SUB: NIC Components PCN & EOL Notifications

RE: Product Change Notification

Product Type: Surface Mount Resistors

NIC Series: NRC and NRCS Series

CARRIER DIMENSIONS: See below

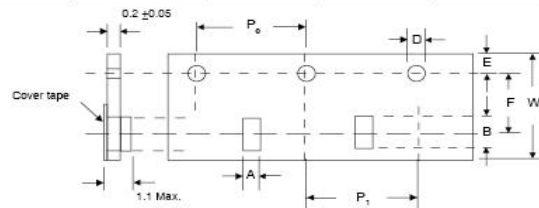
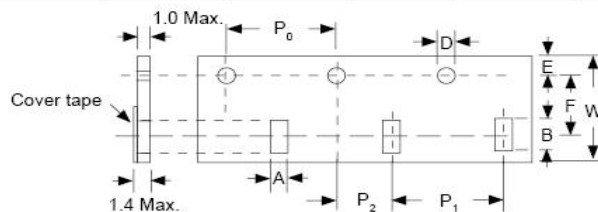
THE FOLLOWING IS NOTICE THAT THE TAPE & REEL CARRIER MATERIAL, REEL QUANTITY AND TAPING DIMENSIONS FOR THE 1210 CASE SIZE **NRC25** AND **NRCS25** SERIES PARTS ARE BEING CHANGED AS DESCRIBED BELOW.

CARRIER MATERIAL: CHANGE FROM EMBOSSED PLASTIC TO PAPER

REEL QUANTITY: CHANGED FROM 4,000 PIECES TO 5,000 PIECES

Discontinued Embossed Plastic Carrier

A	B	D	E	F	P ₀	P ₁	P ₂	W	Qty per 7" Reel
3.0 ± 0.10	3.5 ± 0.10	1.55 ± 0.05	1.75 ± 0.10	3.50 ± 0.10	4.0 ± 0.10	4.0 ± 0.05	N/A	8.0 ± 0.10	4,000

New Paper Carrier

A	B	D	E	F	P ₀	P ₁	P ₂	W	Qty per 7" Reel
2.85 ± 0.20	3.50 ± 0.20	1.5 ± 0.10	1.75 ± 0.10	3.50 ± 0.05	4.0 ± 0.10	4.0 ± 0.10	2.0 ± 0.05	8.0 ± 0.20	5,000
